January 11, 2000

Subject: Application for Equipment Authorization, FCC ID: B32RF350

- Bandwidth plot of the modulated signal:

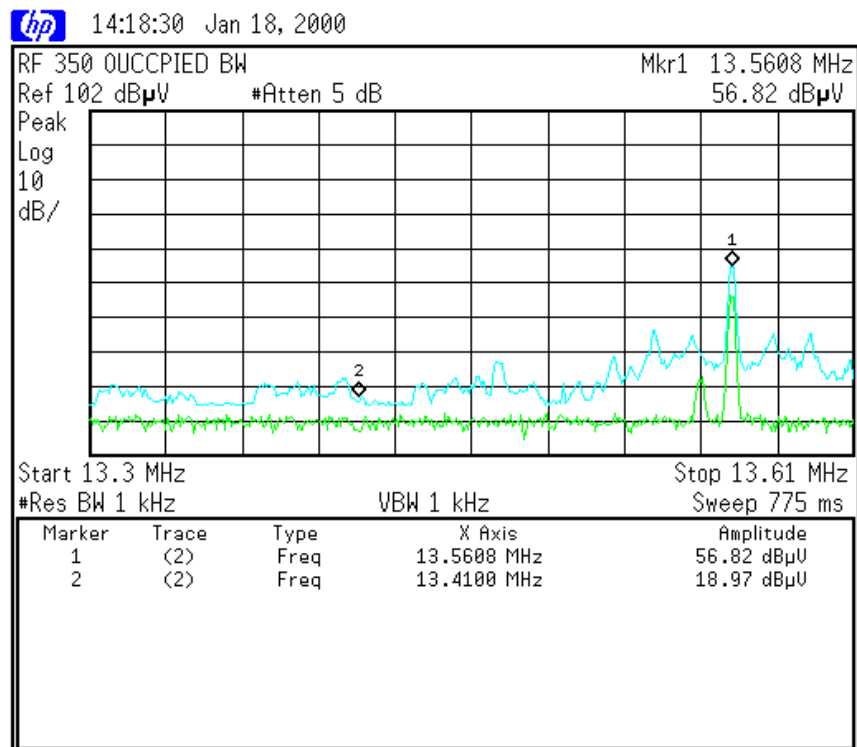
- 5) We understand that operation in the restricted band of 13.36 to 13.41 MHz is not allowed. As demonstration of our compliance please find following requested information.

Please note that the measurement shown in this plot was made with a near field probe. Amplitudes listed are not representative of far field emissions. Additional measurements are included in the measurement report to show that the actual emissions in the restricted band are well below the limits of CFR 47, Pt 15.209.
